**DATE:** MAY 23, 2012  
**RE:** ADDENDUM #2  
**PROJECT:** MAPLE GROVE LAW ENFORCEMENT TRAINING FACILITY RENOVATION  
**OWNER:** CITY OF MAPLE GROVE  
**ARCHITECT:** OERTEL ARCHITECTS, LTD.  
**BID DATE:** MAY 29, 2012, 2:00 p.m.

## MAPLE GROVE LAW ENFORCEMENT TRAINING FACILITY RENOVATION

### DESCRIPTION: ADDENDUM #2

SHEET NO.  
REFERENCE:  
**A1.1**

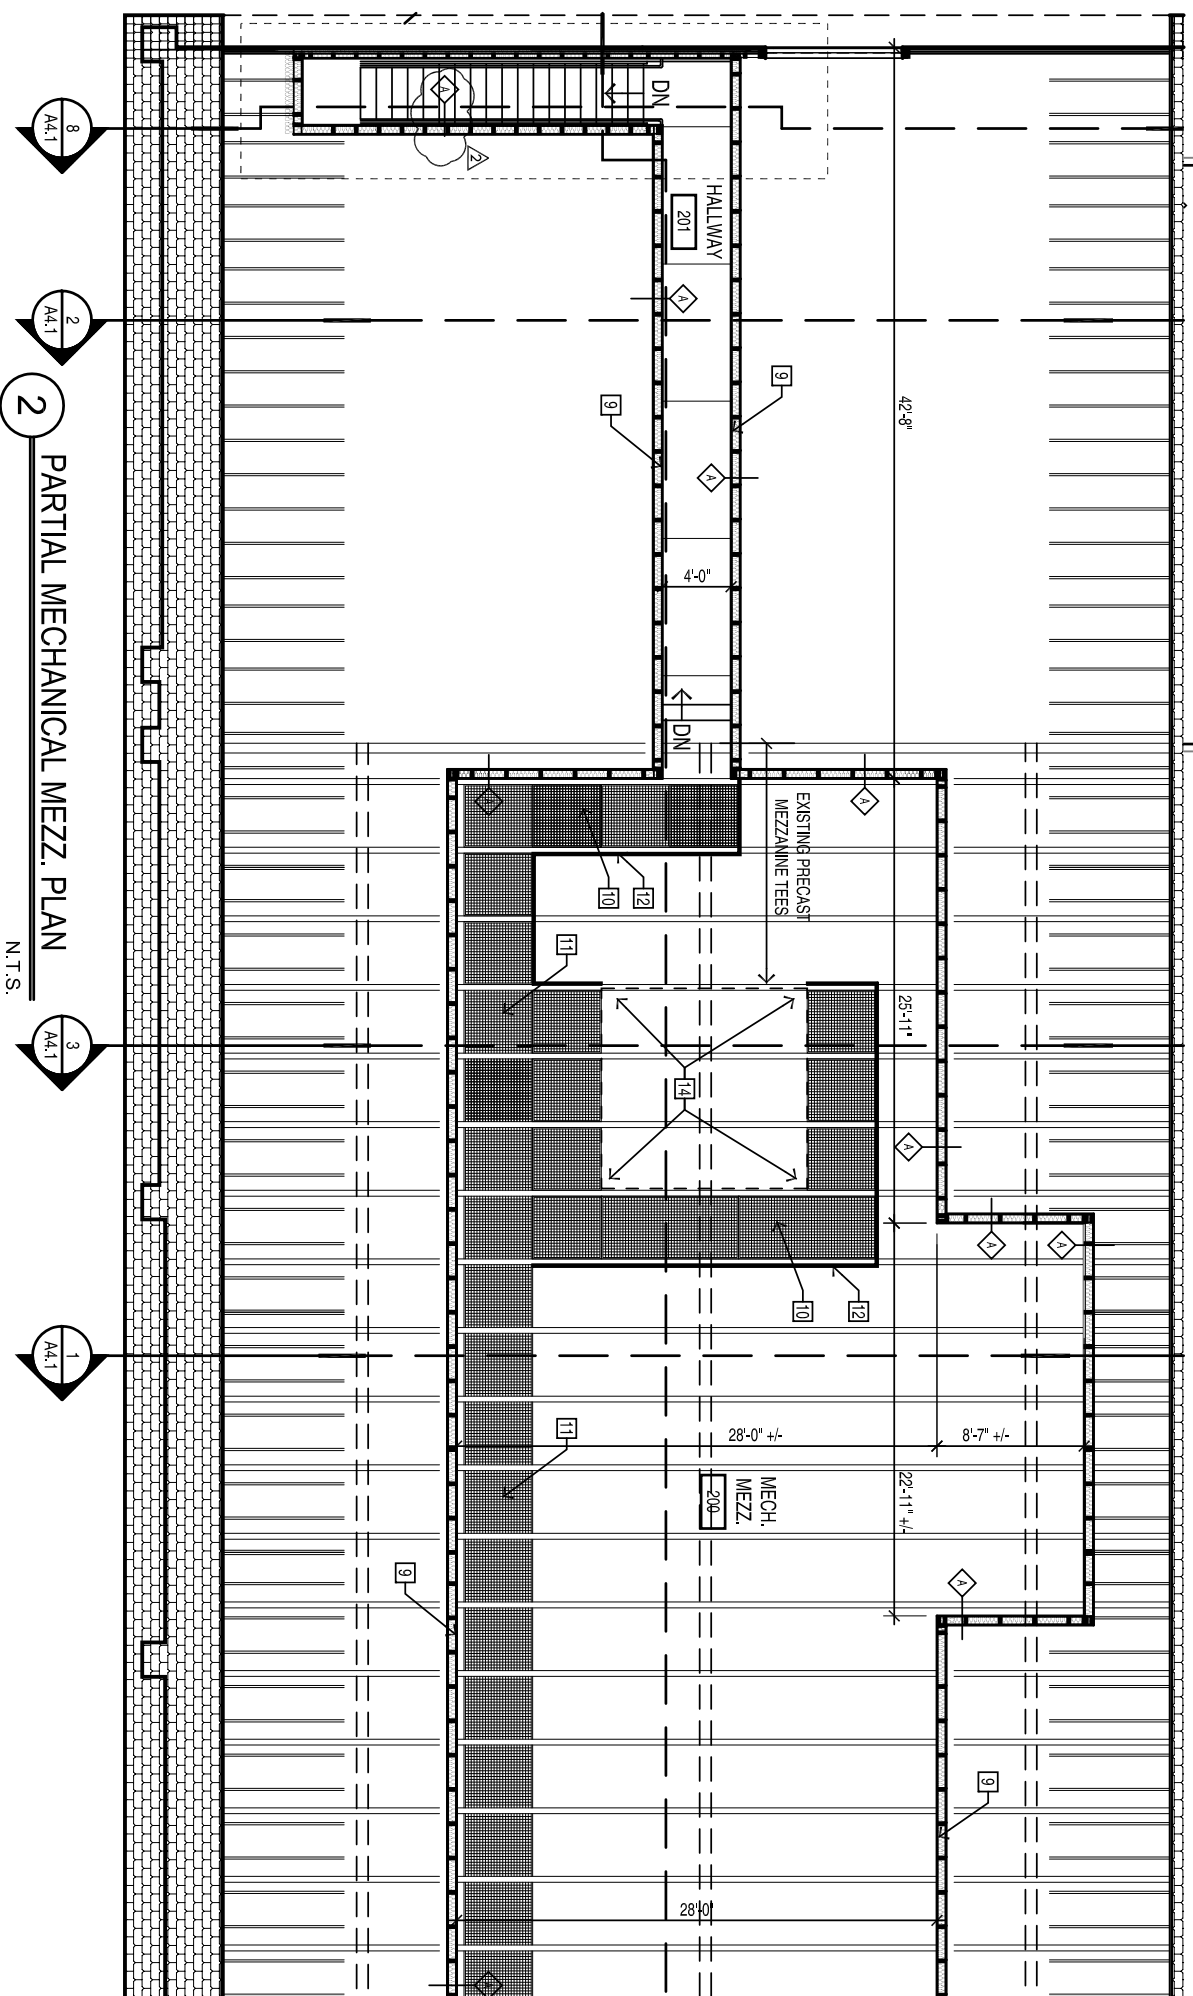
**A1.1:** See attached sheets (two total) for changes.

Wall type "A" amend to read: "5/8" Gyp. Board, Vapor Barrier, Wood Trusses and 2x6 Wood Framing at 24" O.C. Minimum, R-19 Batt Insulation, 1/2" Gyp.Board.

Add note to read: "All vertical walls at mechanical mezzanine / attic space to receive 1/2" gyp. board at "exterior" side of wall (as indicated in wall type "A"), gyp. board will require fitting around and between wood trusses.

**A** 5/8" GYP. BOARD, VAPOR BARRIER, WOOD TRUSSES AND 2x6 WOOD FRAMING  
 AT 24" O.C. MINIMUM, R-19 BATT INSULATION, 1/2" GYP. BOARD.

SHEET NO.  
REFERENCE:  
**A5.1**

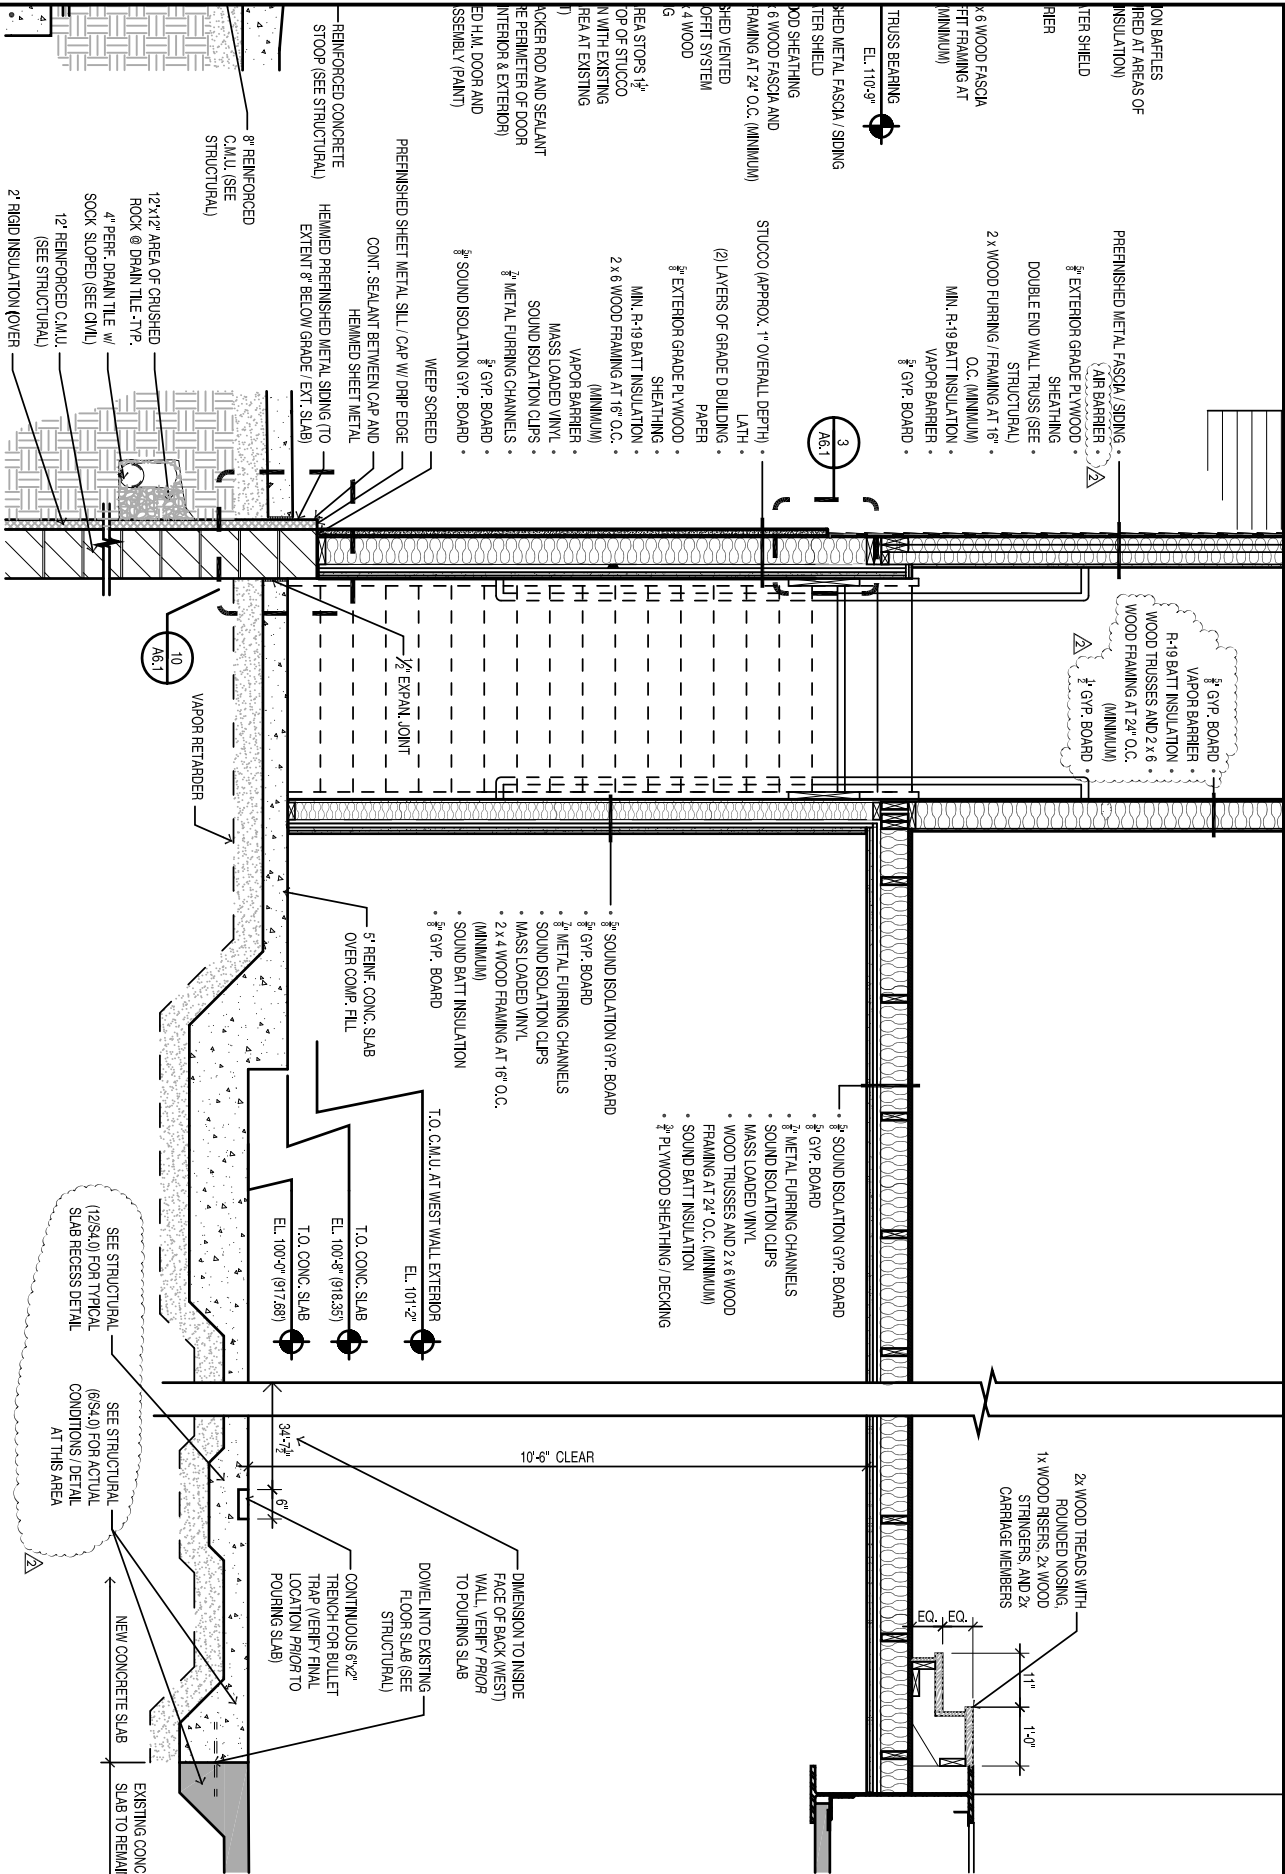
**A5.1:** See attached sheet (one total) for changes.

SHEET NO.  
 REFERENCE:  
**A6.1**

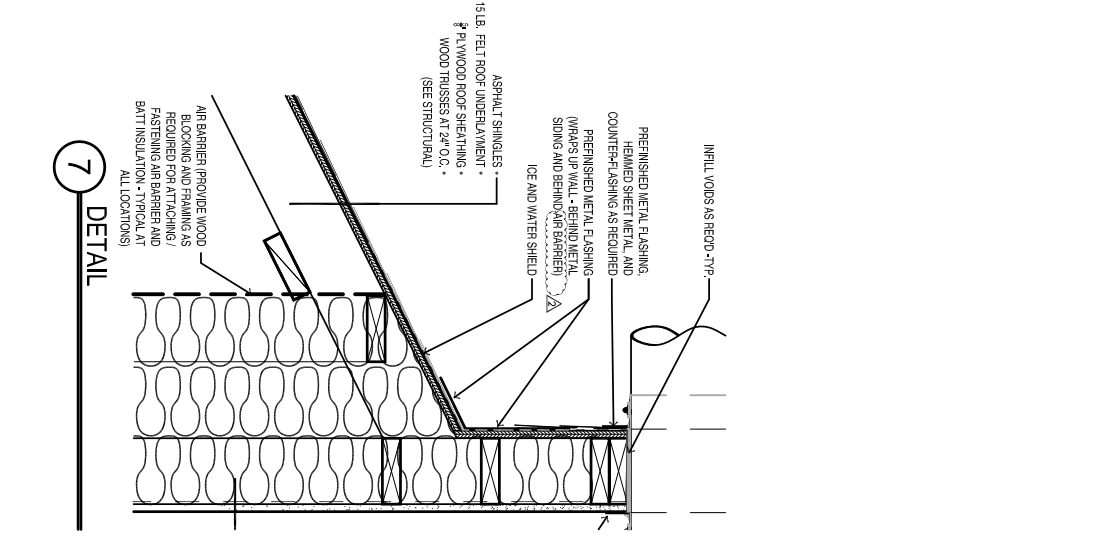
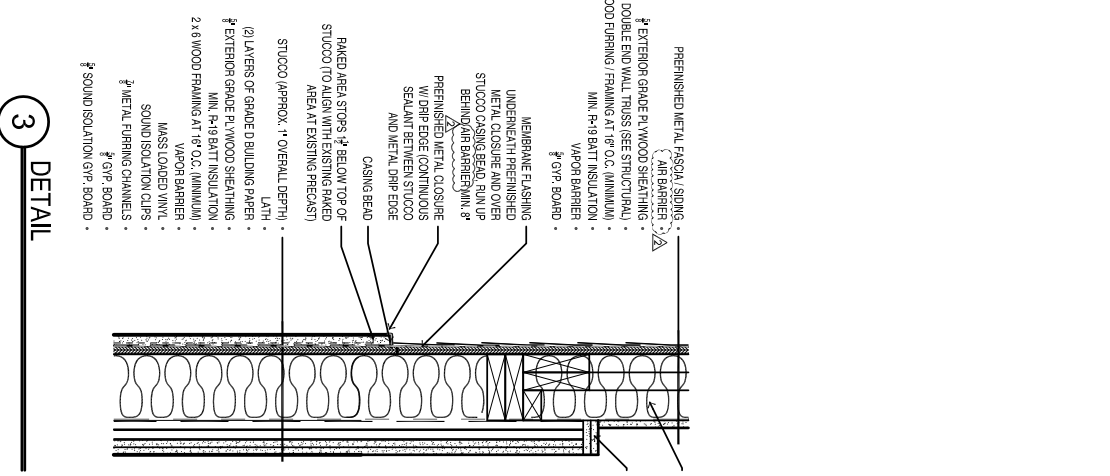
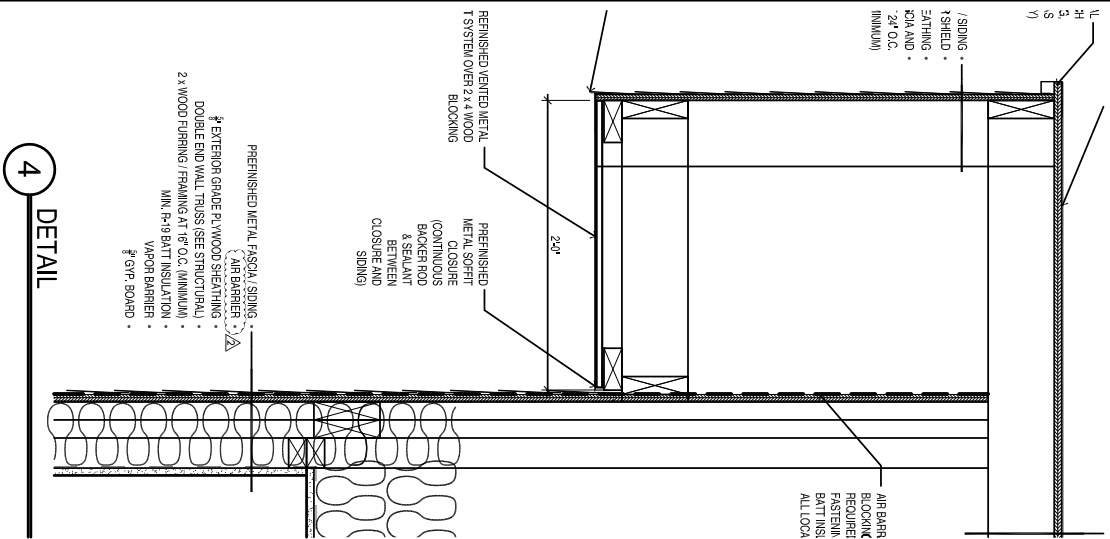
**A6.1:** See attached sheet (one total) for changes.
